UNITED STATES PATENT AND TRADEMARK OFFICE

APPLICATION NO.	FILING DATE	FIRST NAMED INVENTOR	ATTORNEY DOCKET NO.	CONFIRMATION NO.
10/826,084	04/16/2004	Yasuhito Miyata	79873	9251

Office Action Summary	Application No. 10/826,084	Applicant(s) MIYATA, YASUHIITO	
	Examiner Eric Culbreth	Art Unit 3616

DETAILED ACTION

FIG. 8

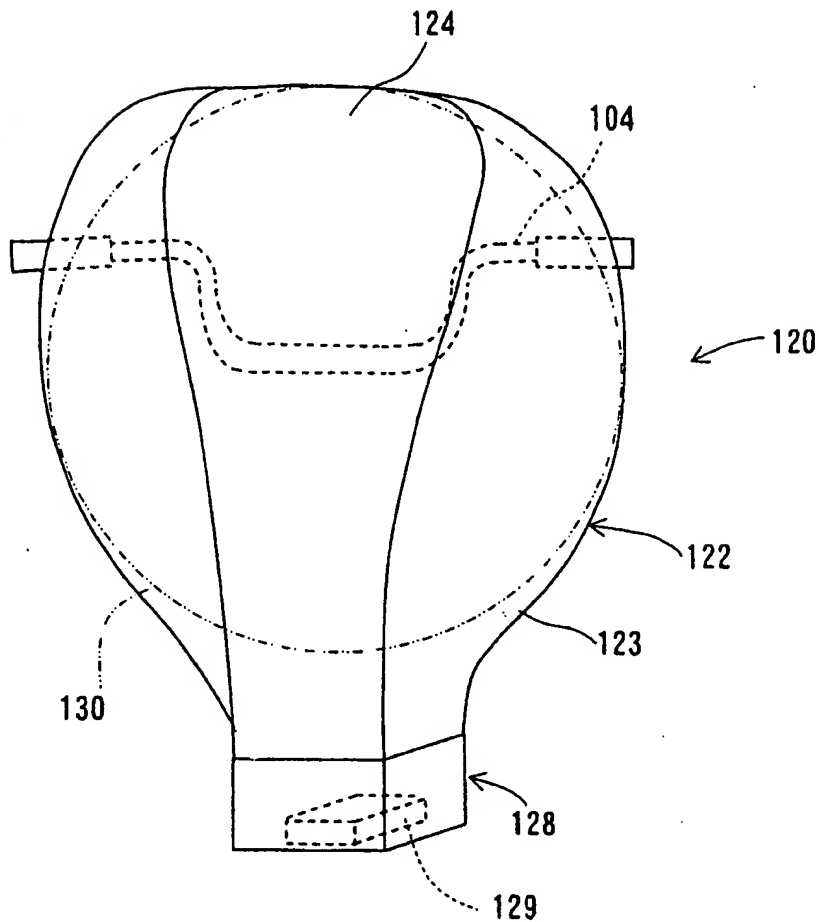
- b. Also, the retainer illustrated in Figure 10 is not clearly able to hold the entire airbag.
2. The drawings are objected to because regarding Figure 8, it is not clear why the outer peripheries of the airbag intersect or cross over at the lower left corner of the bag in the figure (the proposed drawing change to Figure 8 on 8/21/06 actually obviated this objection, but because the replacement sheets were not approved, the objection remains; if the same change to Figure 8 were resubmitted with an amended Figure 10 showing the retainer large enough to hold the entire bag, and with the specification stipulating that Figure 10 is a “schematic” showing, the replacement sheets would most likely be approved). Corrected drawing sheets in compliance with 37 CFR 1.121(d) are required in reply to the Office action to avoid abandonment of the application. Any amended replacement drawing sheet should include all of the figures appearing on the immediate prior version of the sheet, even if only one figure is being amended. The

Not
approved
EC
10/19/06
